**Re: Response to ADEQ Correspondence Dated January 12, 2015
Third Quarter 2014 Progress Report
Whirlpool Corporation
Fort Smith, Arkansas
EPA No. ARD042755389
AFIN No. 66-00048
CAO LIS 13-202**

ENVIRON International Corporation (ENVIRON), on behalf of Whirlpool Corporation, is submitting this response to your January 12, 2015, comment letter (received on January 16) providing comments on the Third Quarter 2014 Progress Report submitted on November 14, 2014. Arkansas Department of Environmental Quality (ADEQ) comments are provided in italics below and the respective response follows.

FIGURE 2: Third Quarter 2014 TCE Isoconcentration Map

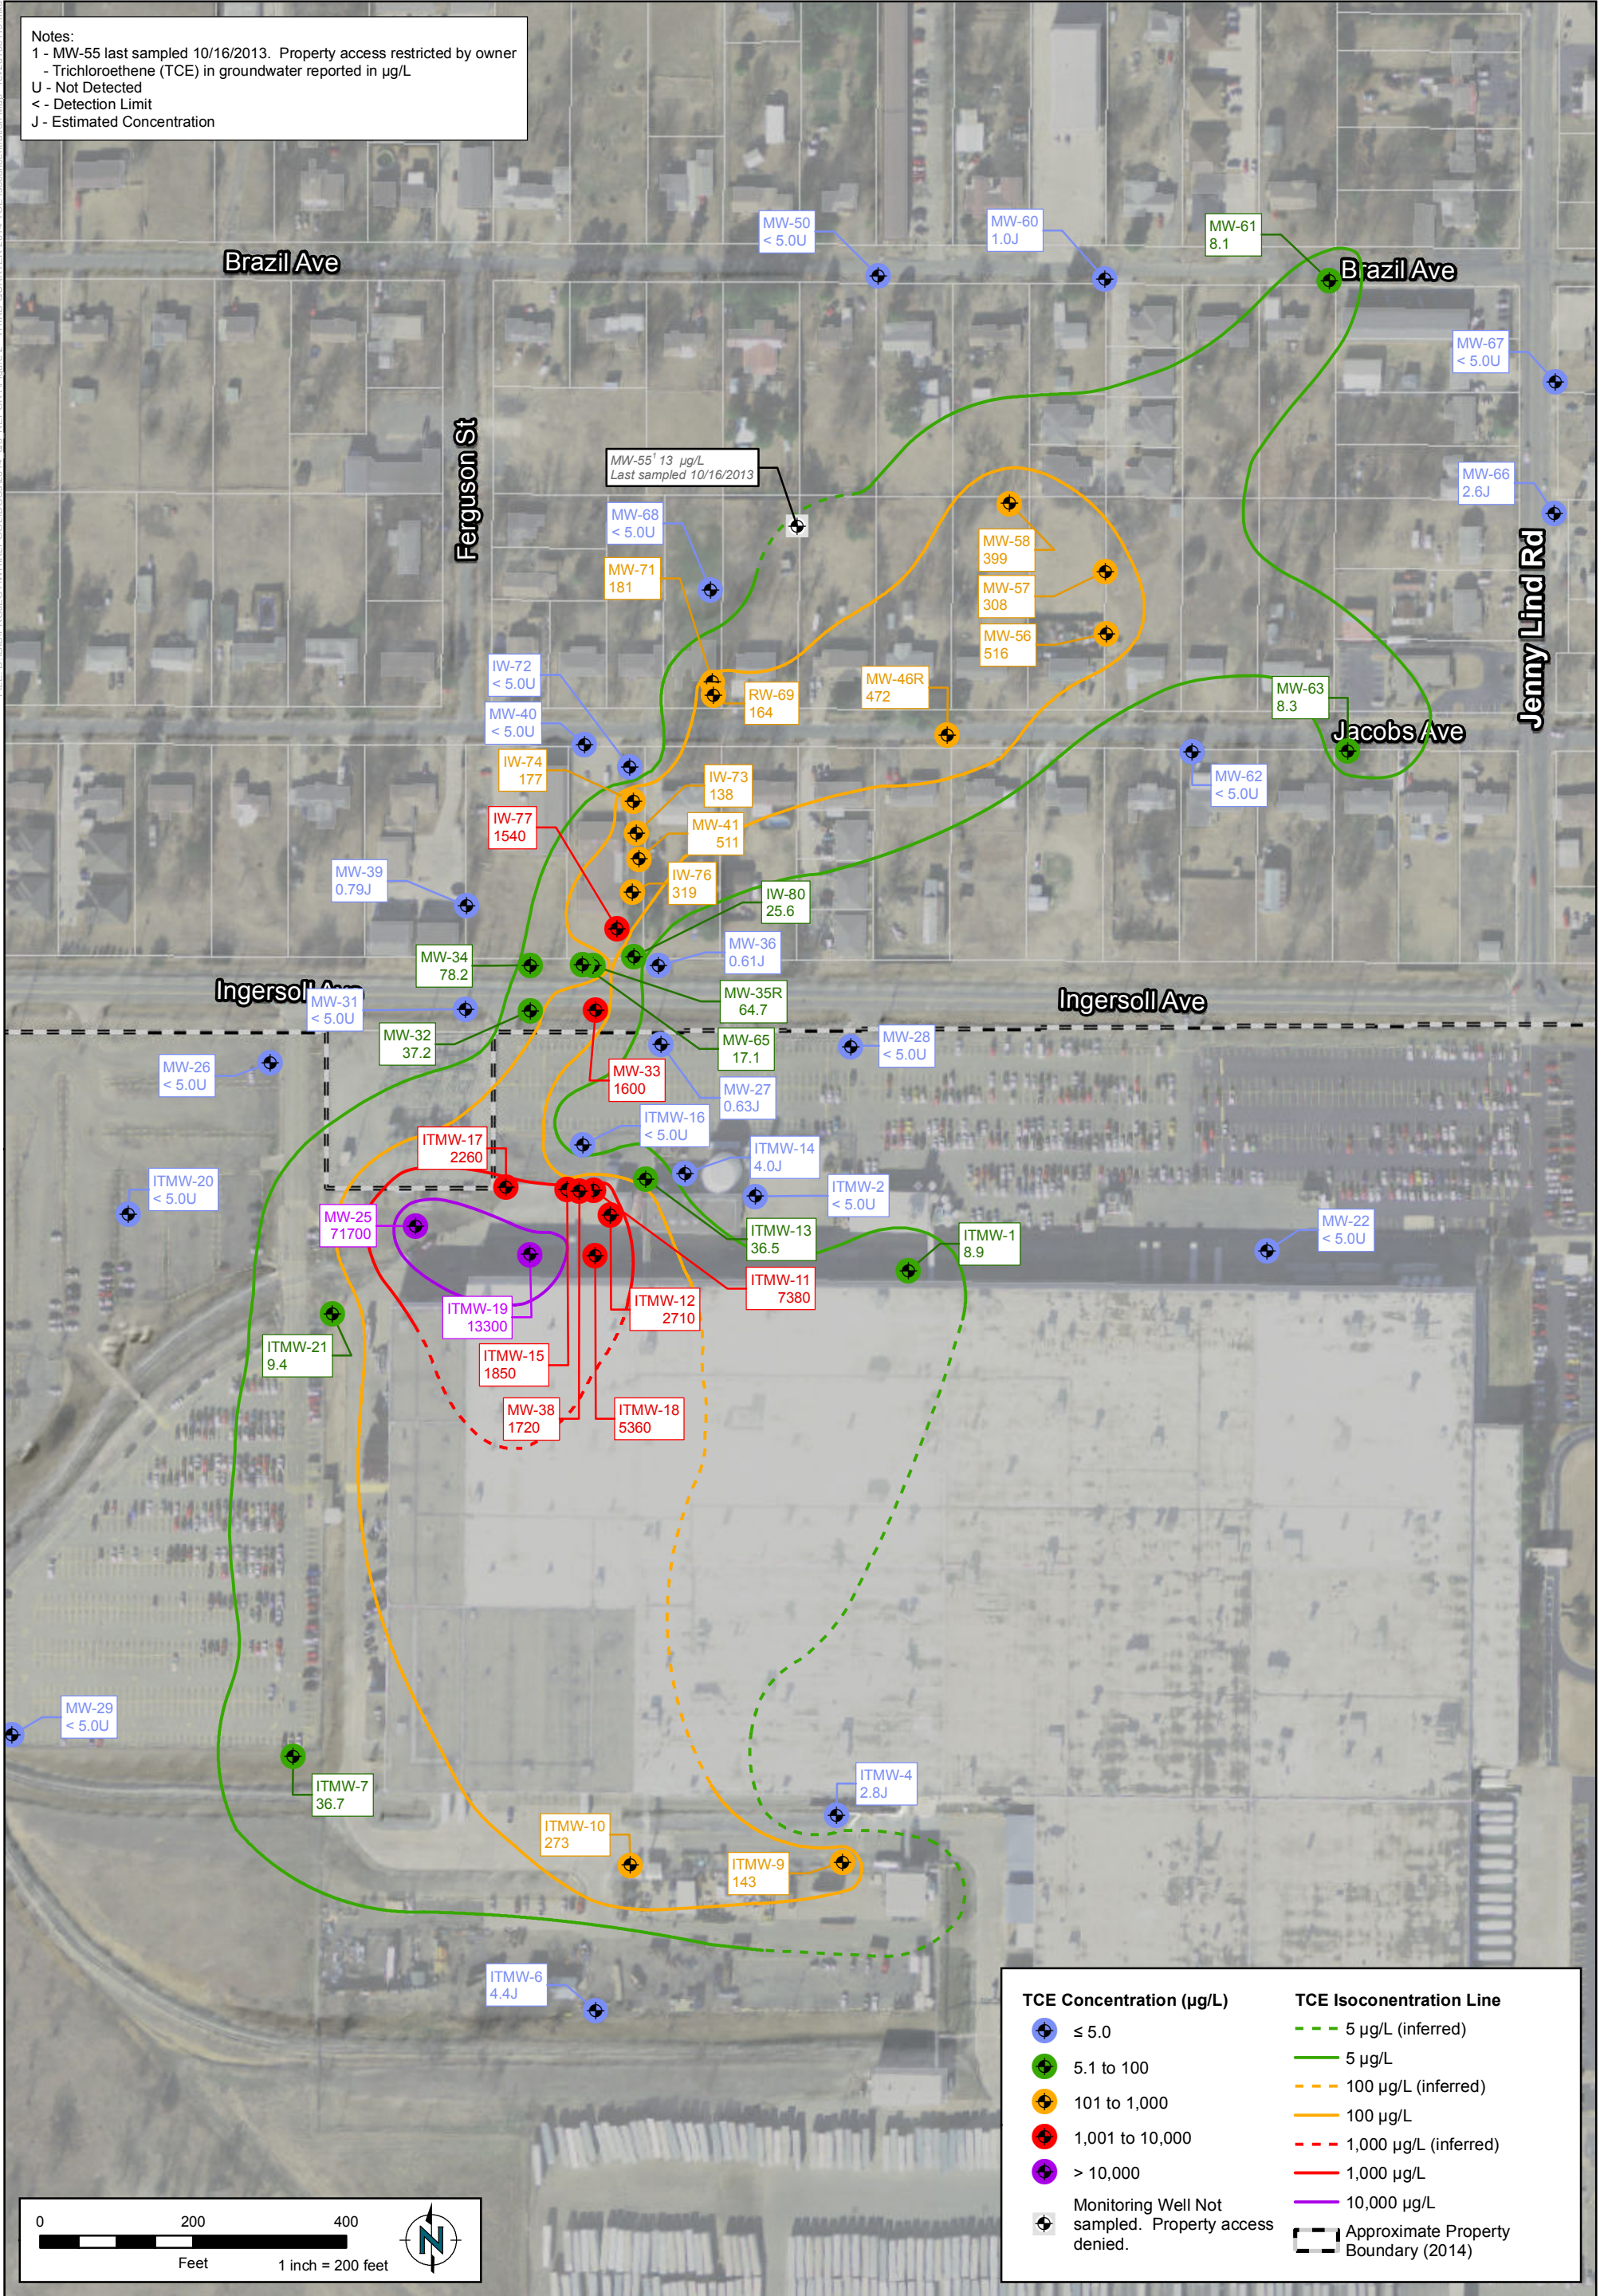
The 5 micrograms per liter ($\mu\text{g/L}$) trichloroethene (TCE) concentration isopleth line on Figure 2 is drawn at the location of monitoring well MW-55. Although currently sampling was not conducted at monitoring well MW-55, the last TCE result obtained for MW-55 on November 15, 2013, revealed the concentration of 13 $\mu\text{g/L}$. The TCE concentration isopleth line should use the most recent result obtained. The 5 $\mu\text{g/L}$ TCE concentration isopleth line should be redrawn to the northwest of MW-55. Please revise.

ENVIRON Response: A revised Figure 2 is attached with a note at MW-55 indicating “Last sampled 10/16/2013” and the isopleth line is dashed to infer the extent of TCE impact in groundwater at this location.
